SCI-823-0.00
PID Nos. 19415, 77366, 79977

Value Engineering Study Report
Draft Stage 2 Design Phase

re: SCI-823-0.00, PID Nos. 19415, 77366 and 79977, Portsmouth Bypass
Harrison, Jefferson, Madison and Porter Townships, Scioto County
Value Engineering Study Report

BORING INFORMATION	
BORING ID	T/ROCK ELEV.
TR-41	482.4
TR-42	476.0
B-37	472.2

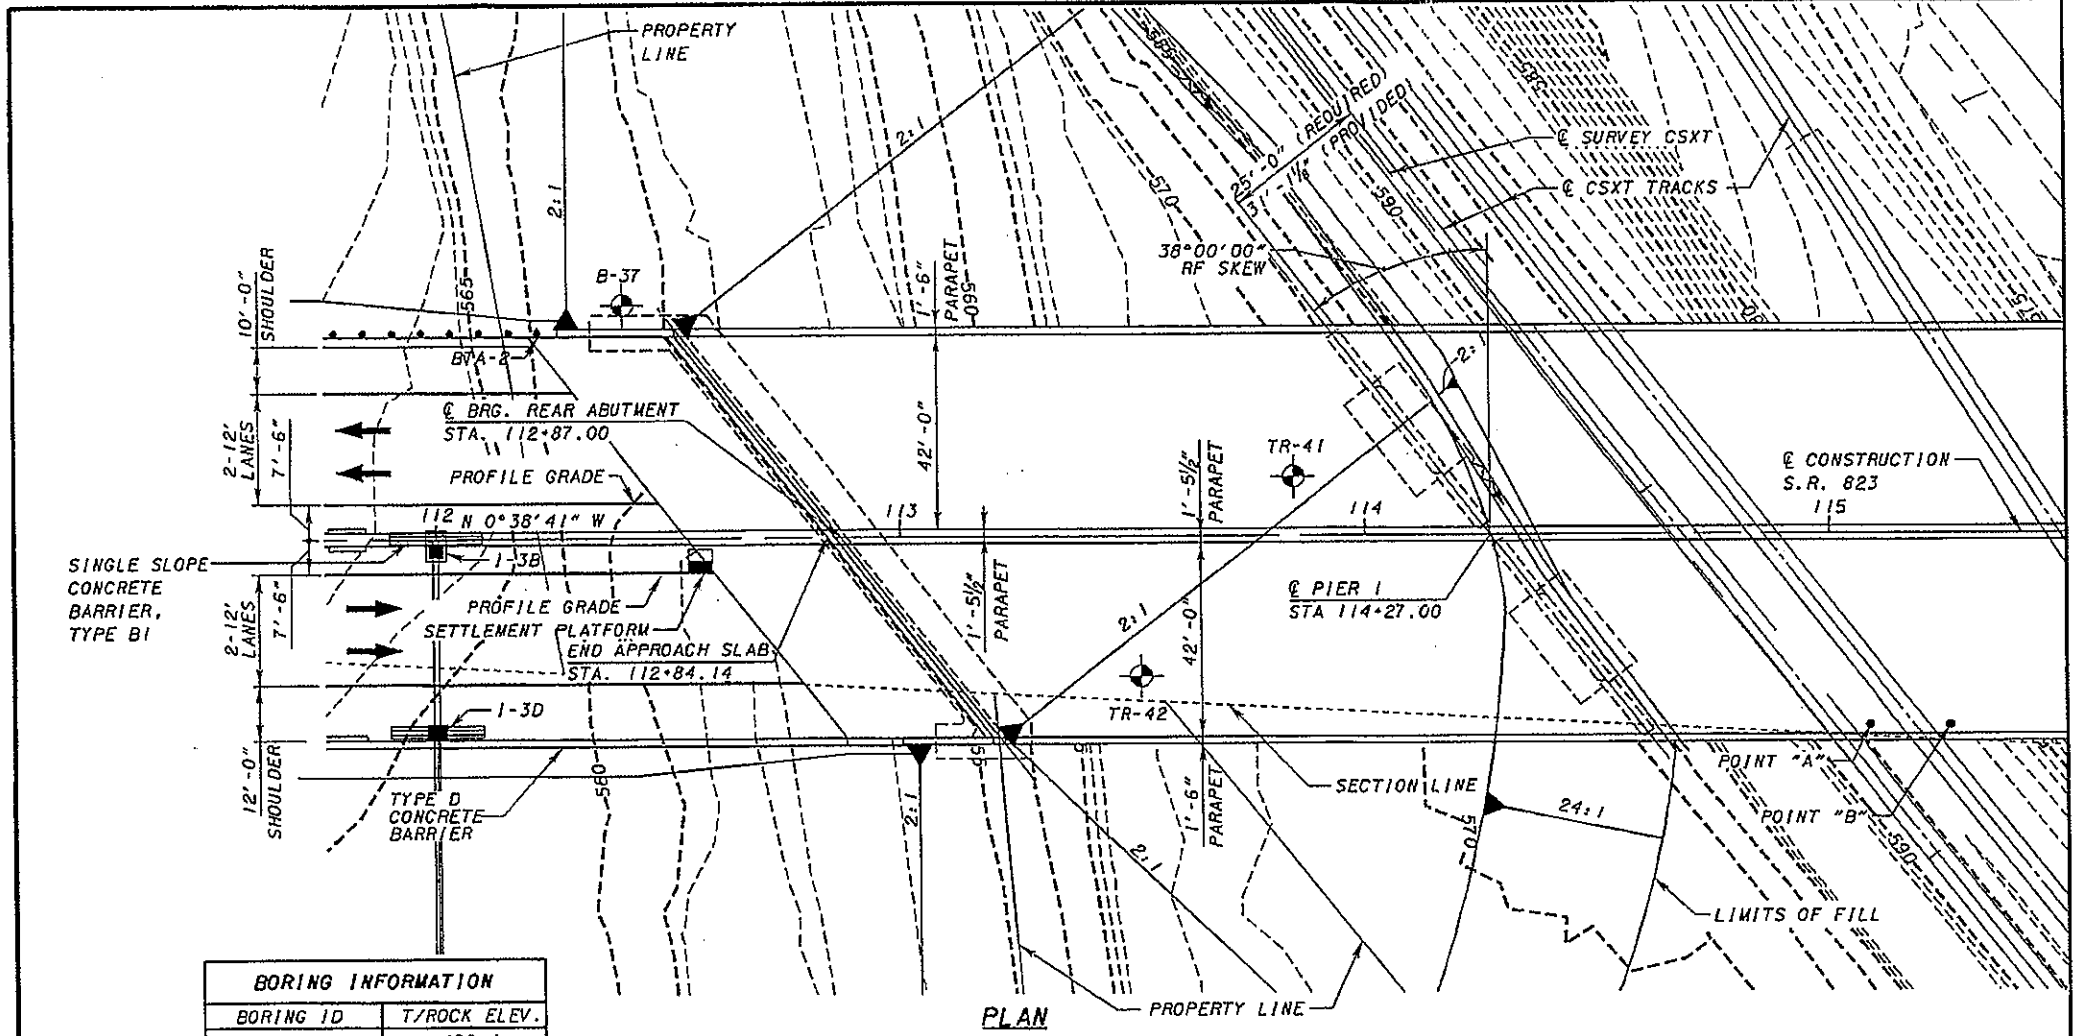
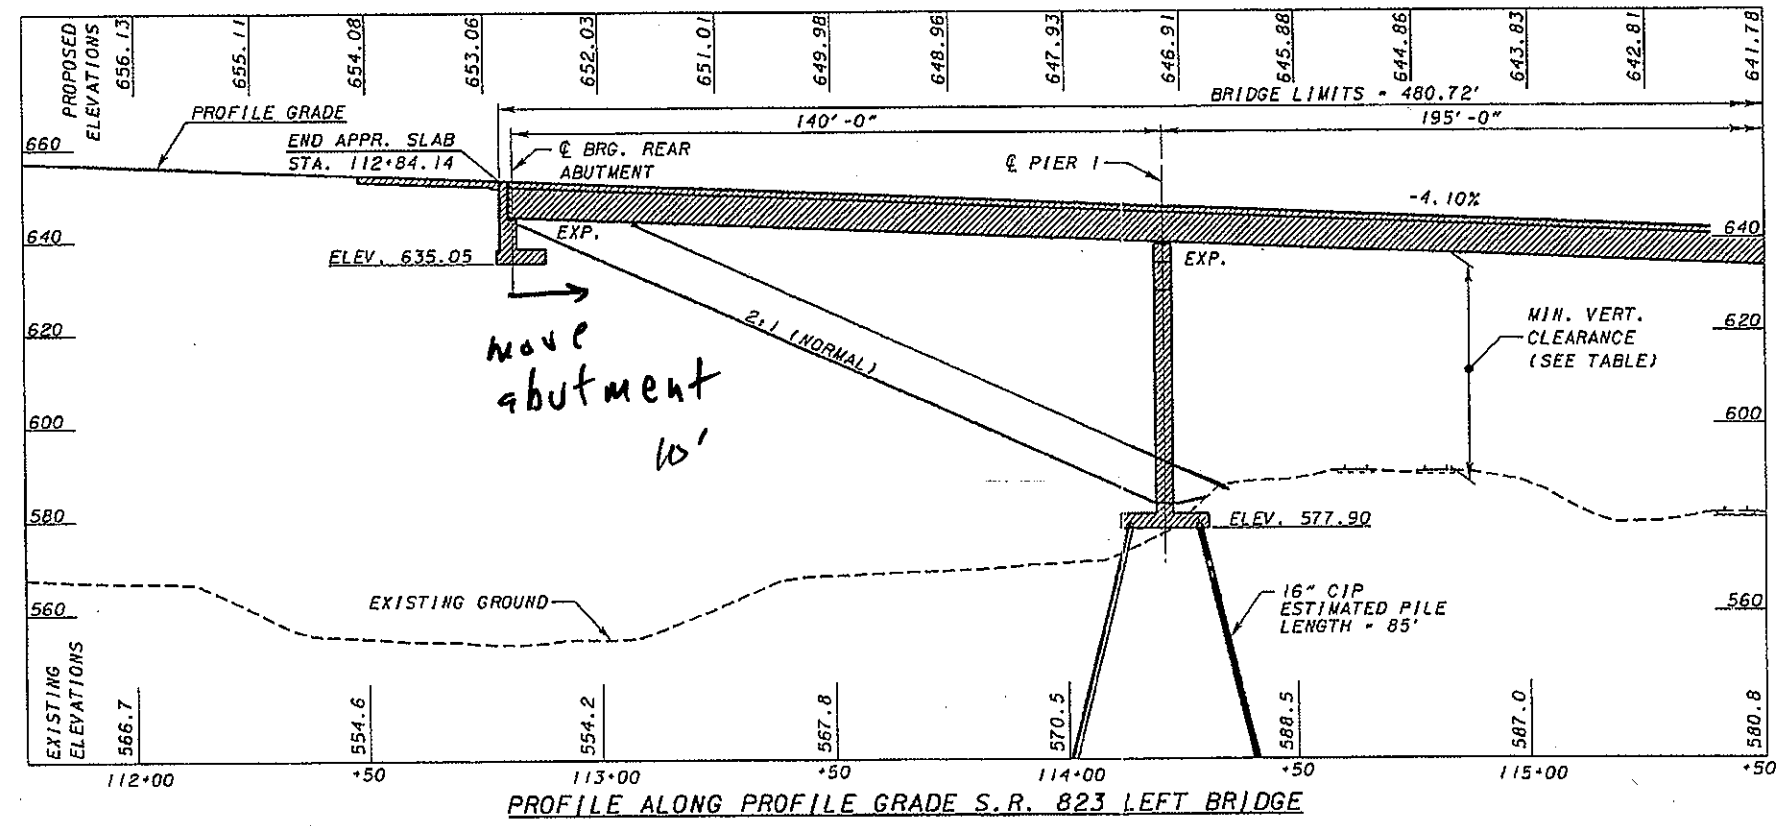
- SCI-823-0067 L - See Alt. No. 65;
- SCI-823-0074 R - No change;
- SCI-823-0117 L - No change;
- SCI-823-0122 - No change;
- SCI-823-0214 L & R - Potential to shorten end spans approximately 10 each;

SITE PLAN
BRIDGE NO. SCI-823-0727 L&R
S.R. 823 OVER SHUMWAY HOLLOW ROAD (TR-234)

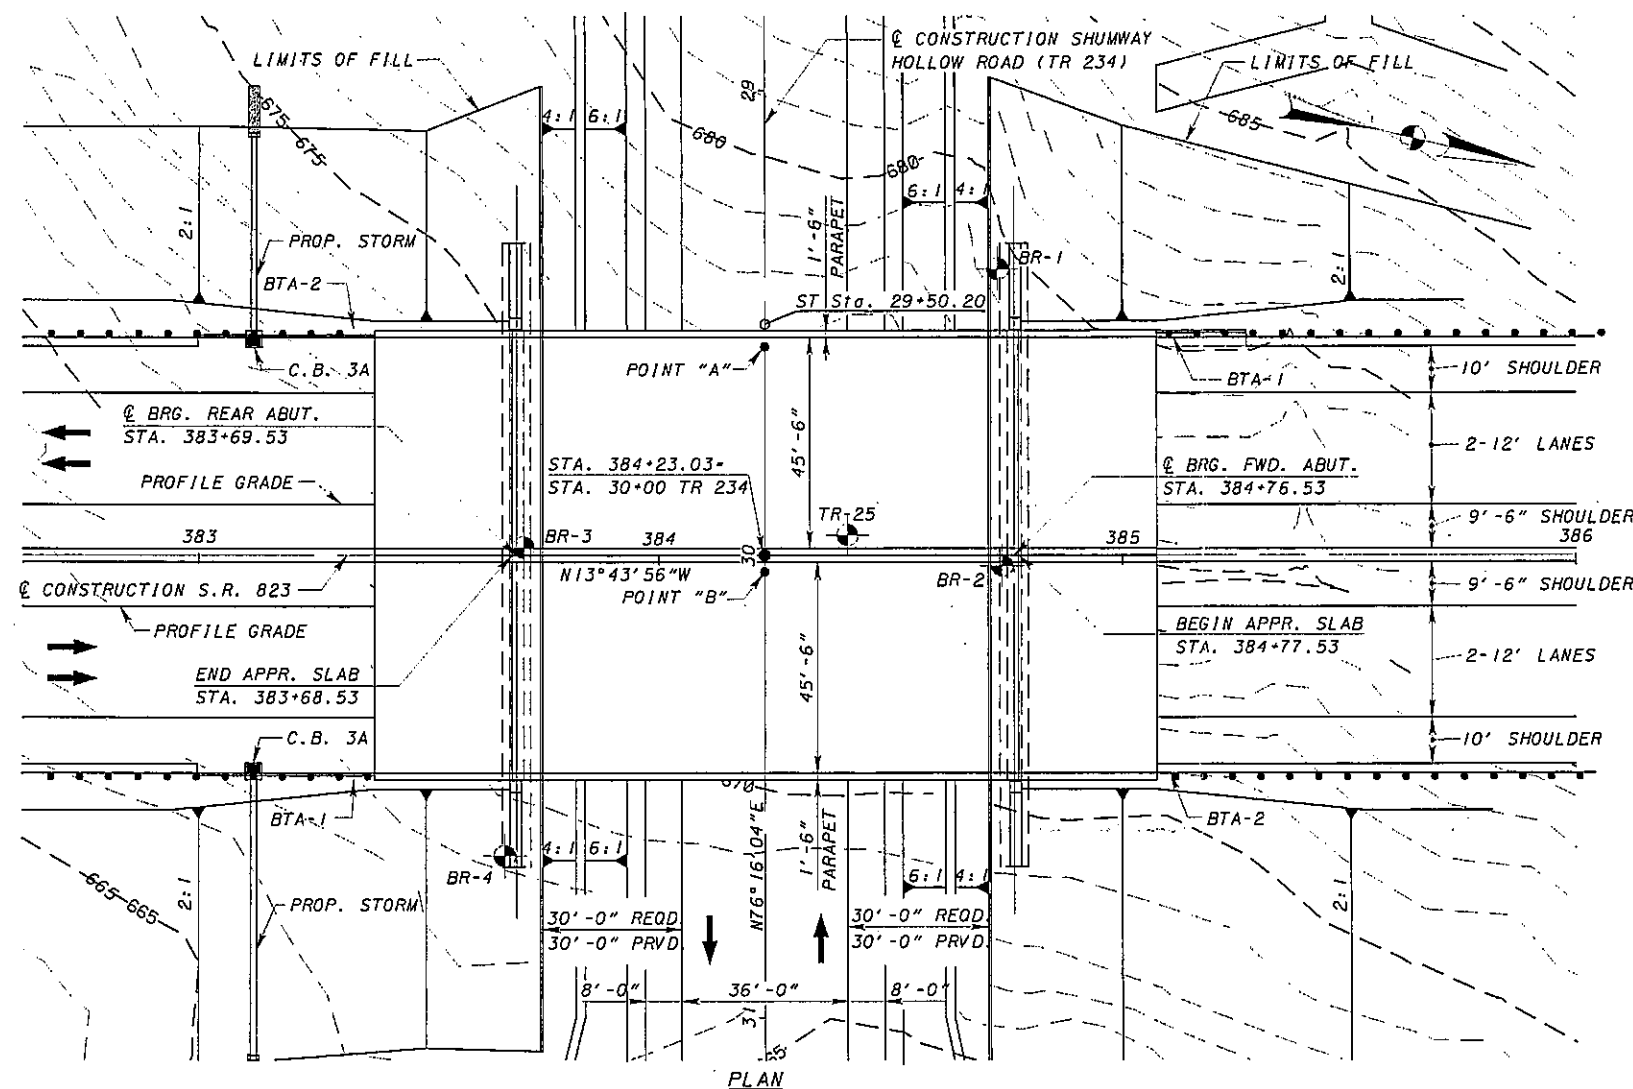
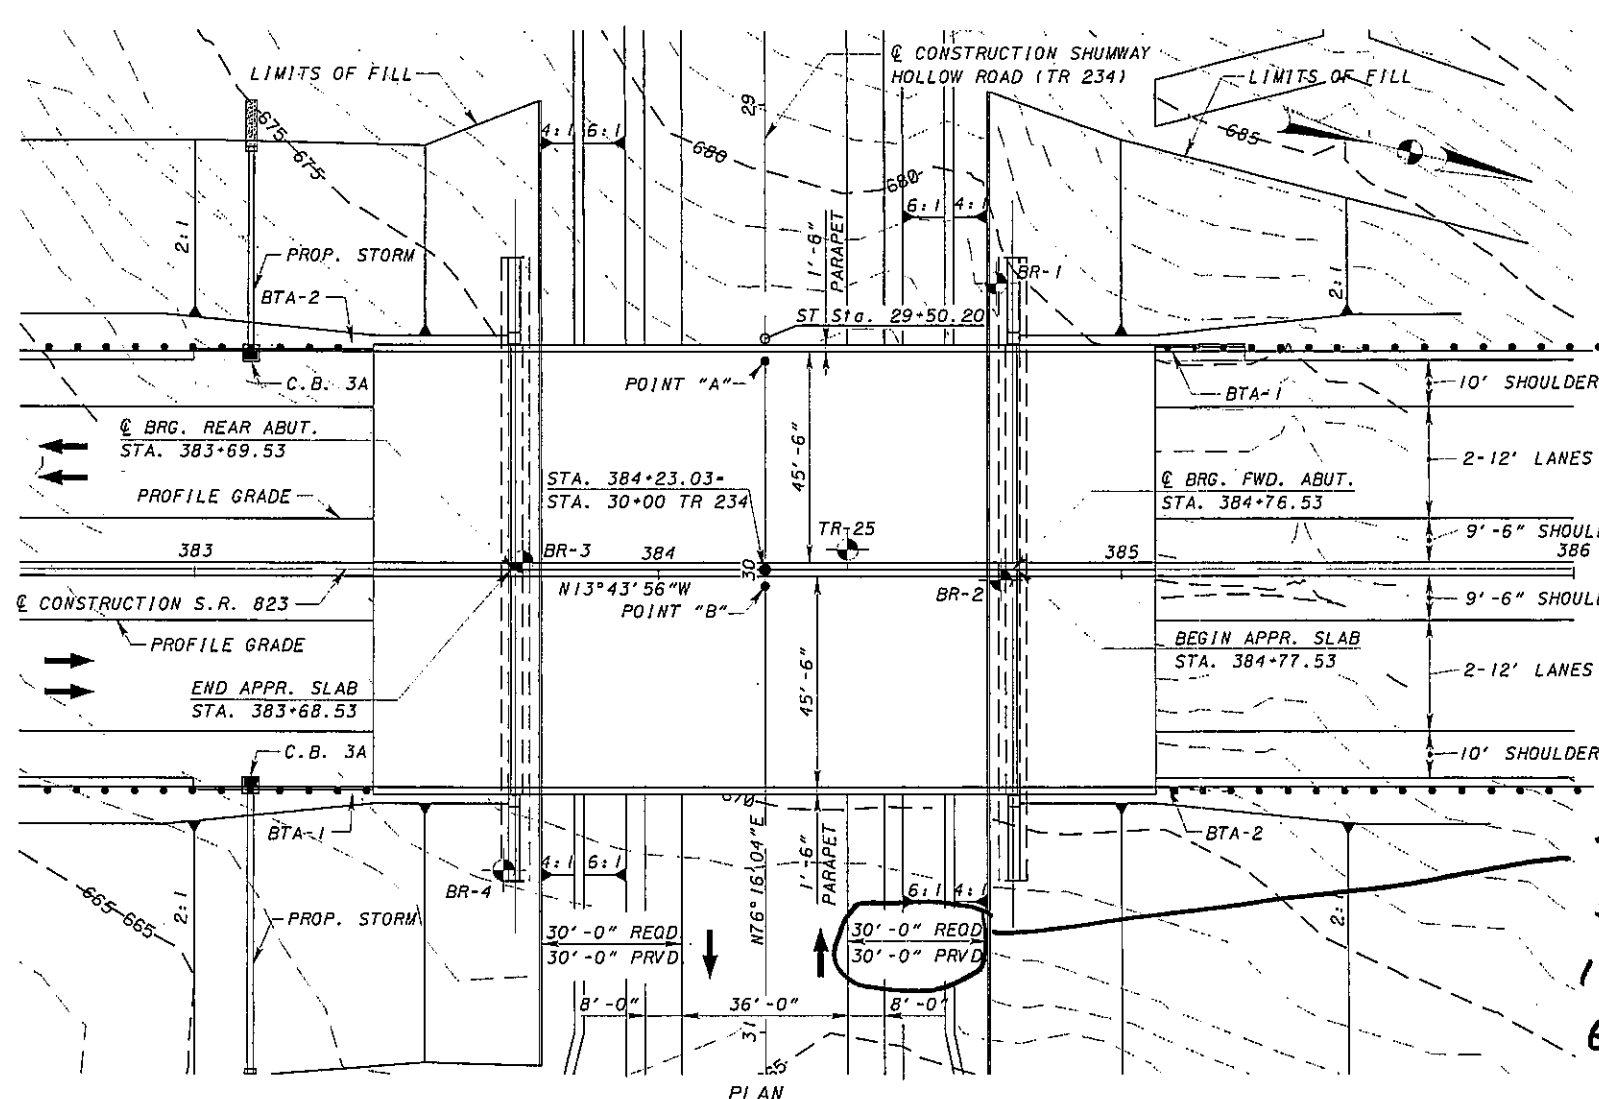
- SCI-823-0229 L & R - No change;
- SCI-823-0727 L & R - Potential to shorten spans based on the required horizontal clear zone;
- SCI-823-0837 L & R - Potential to shorten spans by 5 ft. each;
